City of Santa Barbara California

PLANNING COMMISSION STAFF REPORT

REPORT DATE: May 29, 2008
AGENDA DATE: June 5, 2008
PROJECT ADDRESS: 2506 Calle Andalucia (MST2008-00022)
TO: Planning Commission
FROM: Planning Division, (805) 564-5470
 Jan Hubbell, AICP, Senior Planner
 Jim Rumbley, Planning Technician

SITE PLAN

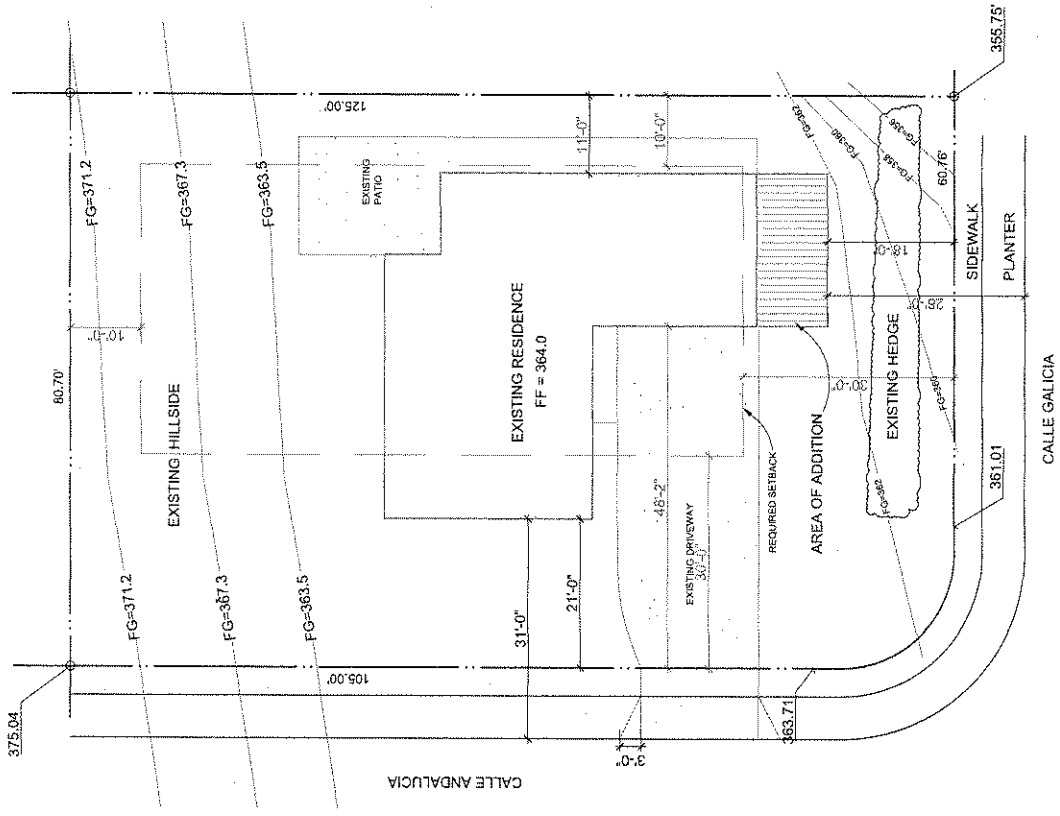
The existing residence on site is non-conforming to both front setbacks. The required front setback in the E-1 zone is 30 feet. The residence encroaches approximately 9' into the front setback along Calle Andalucia, and the garage encroaches approximately 2' into the front setback along Calle Galicia. The revised project is a request to permit 196 sq. ft of living area, which would be used as a storage room/artist workshop, to be attached to the existing garage. The Modification would increase the encroachment into the front setback along Calle Galicia by approximately 10' for a total encroachment of 12'.

The applicant and property owners believe that the Staff Hearing Officer's approval is an insufficient solution. They believe that the 12' proposed encroachment into the front setback is reasonable and consistent with neighboring homes. Staff believes the proposed encroachment

is excessive, especially considering the residence also encroaches 9' into the 30' required front setback along Calle Andalucia (2nd front yard).

The applicant also contends that the proposed addition, which will be at least 15' tall at its highest point measured from the public right-of-way, will be screened by the existing hedge. Staff's position is that the over height hedge is a zoning violation and may be no taller than 3'6" within 10' of the property line and no taller than 8' in the remaining front setback. The hedge must be removed or reduced to comply with the zoning ordinance requirements.

Staff has reviewed the applicant's amended proposal. While the area of encroachment would be reduced, staff believes the concerns raised for the original approval still apply to the revised approach.

The Staff Hearing Officer partially approved the applicant's Modification application, granting an additional 3' encroachment into the required front setback along Calle Galicia. This approval allows a 5' encroachment into the required 30' front setback. Additionally, the Staff Hearing Officer approved a 5' expansion of the garage to the south-west and recommended expanding the garage out 5' to the existing 10-foot setback along the north-east property line. This approval would have allowed an expansion of approximately 305 sq. ft. (gross) by expanding the garage in three directions. However, the revised plans show that the residence is located only 1' from the 10-foot setback along the north-east property line, so an expansion of approximately 205 sq. ft. (gross) is possible. The abatement of zoning violations involving storage of items in the setback and over height hedges in the front yard along Calle Galicia was required as a condition of the approval.

Staff believes that the project as proposed by the applicant excessively increases the encroachment of a non-conforming building in the required front setback. The Staff Hearing Officer's decision addresses the property owners' need for a storage room/artist workshop without an excessive encroachment into the setback. Therefore, staff recommends that the Planning Commission uphold the Staff Hearing Officer's action on the project by making the findings detailed in the SHO Resolution (Exhibit E). Additionally, Staff recommends upholding the condition stipulated by the Staff Hearing Officer requiring the abatement of the existing storage and hedge violations. Staff will pursue these violations as a zoning enforcement case.
